Serial No. NA3-08-090R
Docket No. 52-017
COL/BCB

DOMINION VIRGINIA POWER
NORTH ANNA UNIT 3 COMBINED LICENSE APPLICATION
RESPONSE TO REQUEST FOR ADDITIONAL INFORMATION LETTER NO. 020
(FSAR CHAPTERS 9 AND 11)

RAI Question No. 09.05.01-16

RAI Question No. 09.05.01-17

Figure 9.5-201 Fire Protection System; Main Yard Loop

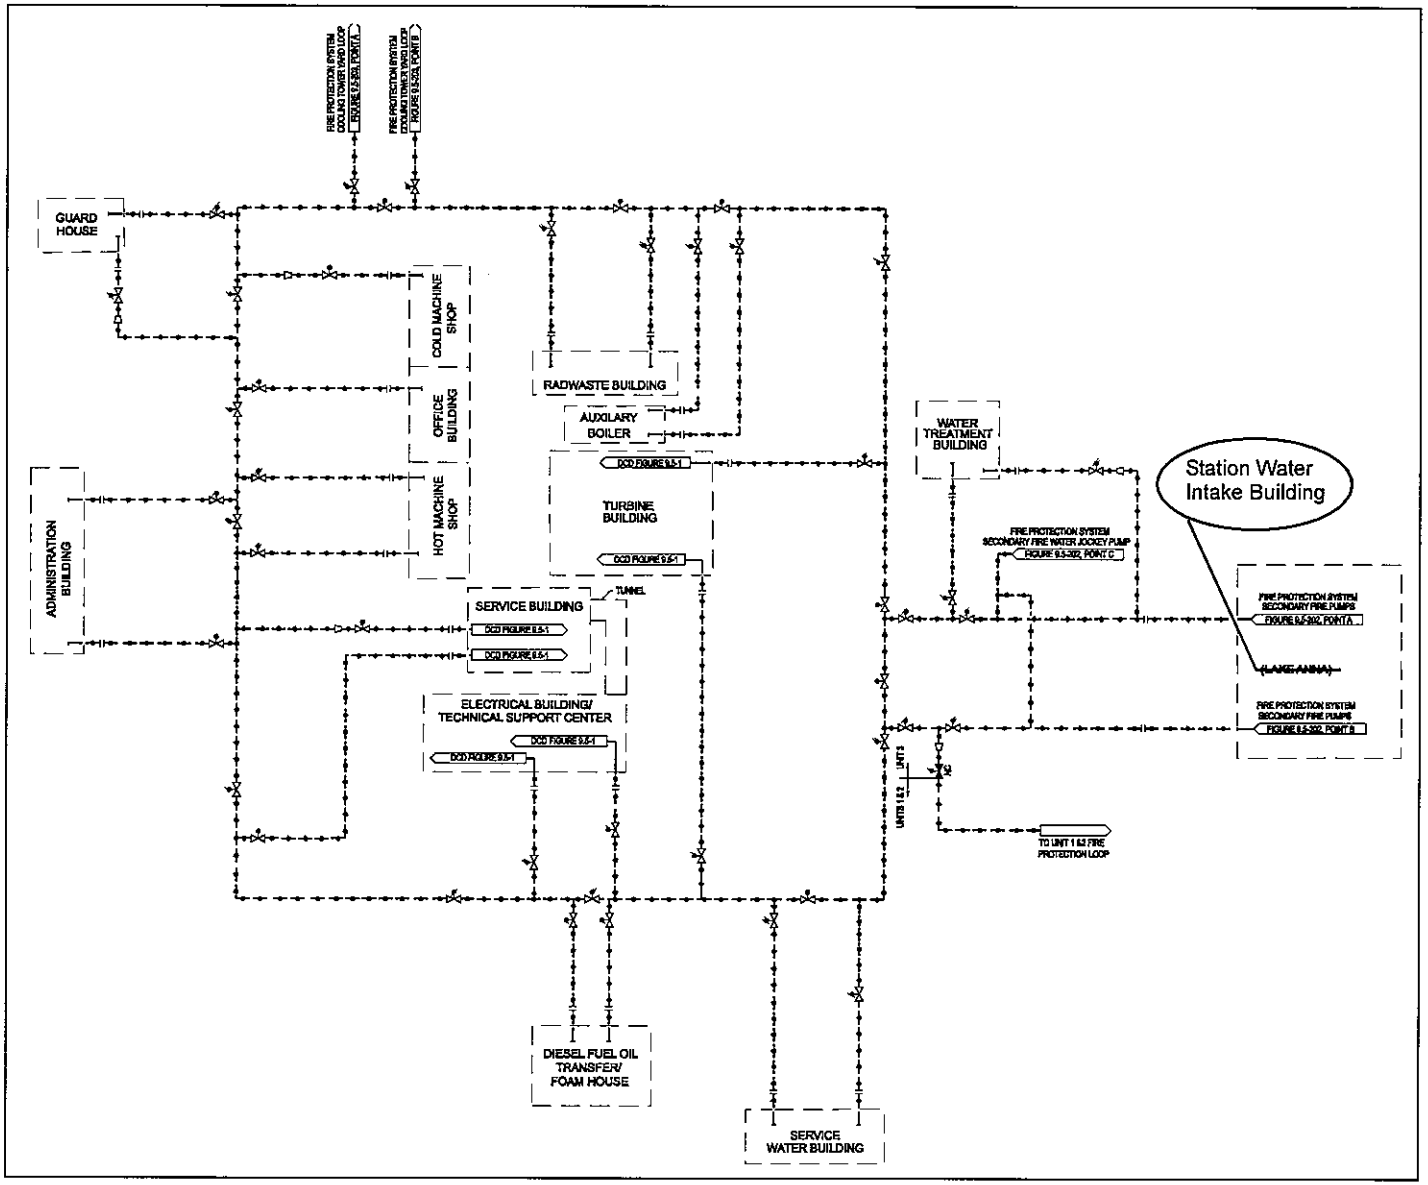
Figures 9.5-201, 202, and 203 implement COL information Item 9.5.1.4-A and show the fire water loads of the plant. According to Appendix 9A FHA, there are suppression systems for the Fire Pumps, Warehouse, and Dirty/Clean Lube Oil Storage Tanks, but these systems are not indicated on Figure 9.5-201. The applicant should verify that these locations require a fire water supply and show these locations on Figure 9.5-201. The Warehouse is not identified on Figure 9A.2-33R but is incorporated by reference by North Anna 3's COLA Appendix 9A FHA. The applicant should include the Warehouse on Figure 9A.2-33R. A typo has been indentified on page 9-42 of North Anna 3's COLA Appendix 9A FHA. The applicant should change F7454 to F7154. Additionally, Figure 9.5-1 is identified by North Anna 3's COLA Section 9.5.1.4 as applicable to North Anna 3. Figure 9.5-1 shows one "From Yard Piping" connections to the Turbine Building while Figure 9.5-201 shows that there are two to "DCD Figure 9.5-1" connections. The applicant should revise Figure 9.5-1 as applicable.

- The fire protection pumps, located in the Station Water Intake Building, will be protected by fire water. FSAR Figure 9.5-201 will be revised to show a fire water supply to the Station Water Intake Building.

- The North Anna Unit 3 design does not include a dedicated warehouse building, but will use existing warehouse buildings that support North Anna Units 1 and 2. Therefore, FSAR Figures 9.5-201 and 9A.2-33R do not need to be revised to show a Unit 3 warehouse. FSAR Section 1.1.1.7, Appendix 9A, and the Departures Report will be revised to reflect this departure from the DCD.

- The lube oil storage tanks require a fire water supply. The fire water supply to these tanks is part of the ESBWR standard plant design and, therefore, is not shown on FSAR Figure 9.5-201.

- The typographical error in FSAR Section 9A.7 (COLA Revision 0, Page 9-42) will be corrected. "F7454" will be changed to "F7154."
- FSAR Figure 9.5-201 is consistent with DCD Revision 5 Figure 9.5-1, which shows two yard connections to the turbine building.
